**Working Party on the Transport of Dangerous Goods**

**Sixty-eighth session Geneva, 15 – 19 Mai 2000**

**Proposal transmitted by Italy**

**PART 9.1 – SCOPE, DEFINITIONS AND CLASSIFICATIONS AND REQUIREMENTS FOR THE APPROVAL OF THE ADR VEHICLES**

APPENDIX 1 – Explanatory layout of the procedures for ADR vehicles

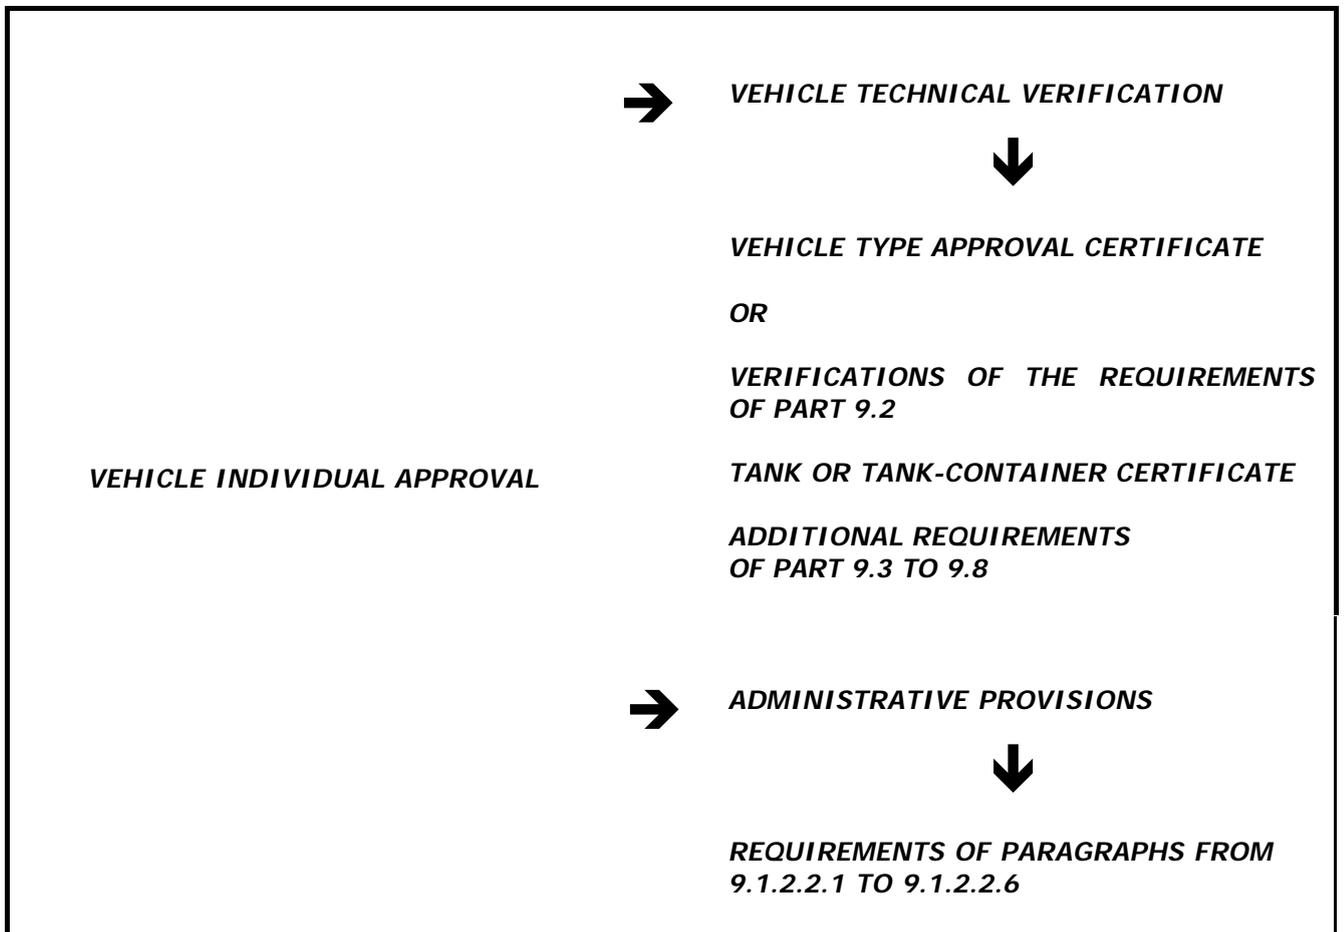
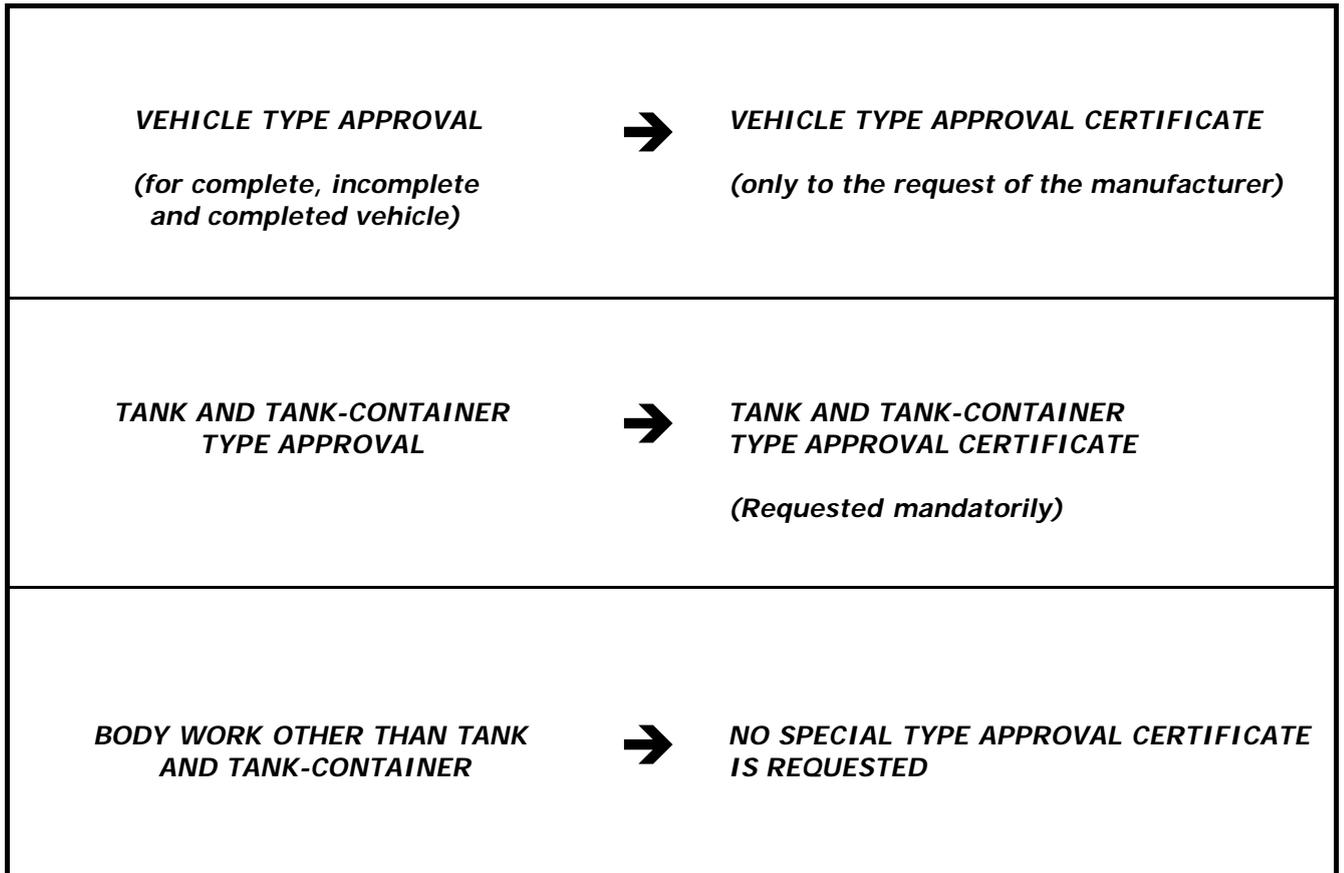
Here below are listed the necessary steps that the vehicle must follow to grant the Certificate of Approval (see APPENDIX 1):

- APPENDIX 1 New added
- 9.2 New title
- 9.2.1 A new sentence as reminder of the Transitional Provisions in paragraph 1.6.5 added.
- 9.8 New Chapter

*The explanatory layout of the mentioned procedures in the paragraphs 9.1.2.1 and 9.1.2.2 for ADR vehicles is given in APPENDIX 1.*
